SUNDRY NOTICES AND REPORTS ON WELLS
Do not use this form for proposals to drill or to re-enter an abandoned well. Use Form 3160-3 (APD) for such proposals.

2. Name of Operator
DEVON ENERGY PRODUCTION COMPANY, LP

8. Well Name and No.
M #1

9. API Well No.
30-025-21893

CURRENT WELLBORE

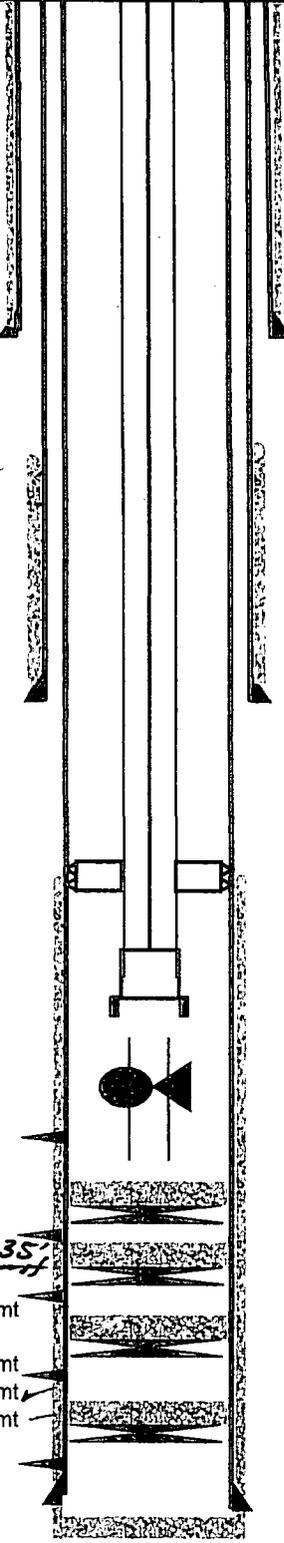
- 9366-98
- 10755-59
 12306-316
 12100-
 11894 11882
 12306-316
 1318-200
- Perforations**
- 11046-11233 CIBP @ 11000 +35' cmt
 - 10664-11233 (squeezed)
 - 12254-12264 CIBP @ 13300 +35' cmt
 - 13138-13148 CIBP @ 13100 +35' cmt
 - 13315-13406 CIBP @ 12200 +35' cmt
 - 13155-70
- CIBP 10695-35'
 ←-if

tubing fish from 8920-9740'

CURRENT WELLBORE

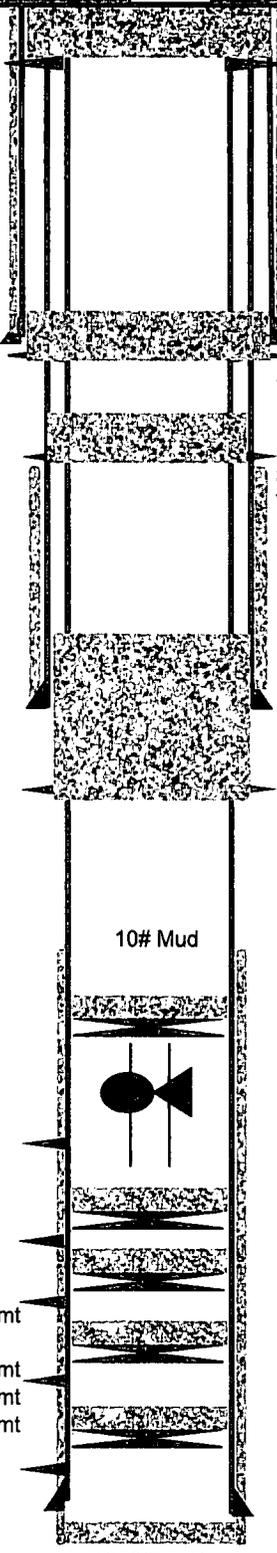
Proposed:
 1. Perf at 140'.
 2. Pump 10 sx Cl C cmt in/out from 140-3'.

Proposed:
 1. Perf at 400'.
 2. Pump 30 sx Cl C cmt in/out from 400-300'.

Proposed:
 1. Perf at 2700'.
 2. Pump 30 sx Cl C cmt in/out from 2700-2600. (B.)

Proposed: **5260 (T/Del & Sloe)**
 1. Perf at 5150'.
 2. Pump 30 sx Cl C cmt in/out from **5150-5050**.
5260
400' Tag

Proposed:
 1. Set CIBP @ 8910'.
 2. Spot 20 sx Cl C cmt from **8810-8910'**.
8770
